Technical Service Bulletin: tsb100282

Released Date: 28-Jun-2004

New Direct Drive Fan Hub Washer

Figure 1.

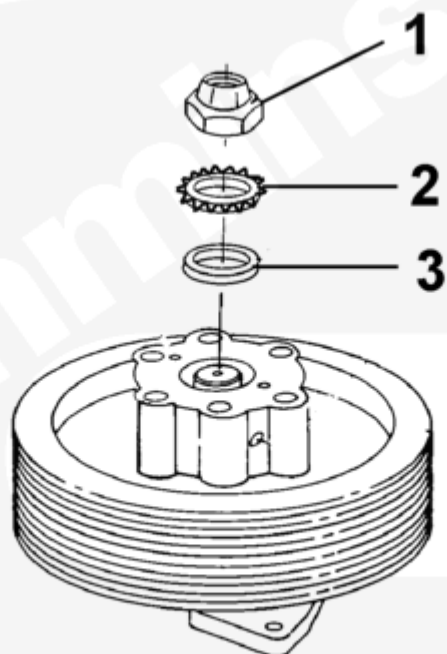
This Technical Service Bulletin introduces a new hardened fan hub bearing washer for the direct drive type fan hub used on QSK45 and QSK60 series engines equipped with a direct drive fan hub. The new washer has increased material hardness. The washer is located between the two bearings in the fan hub. Its purpose is to maintain preload on the bearings within the fan hub to increase durability.

The washer is denoted by item 3 in Figure 1 below.

Fan Hub Washers	
Part Number	Washer Status
3171138	Superseded
3635836	Current for production and service

Engine Serial Number first is 33156262.
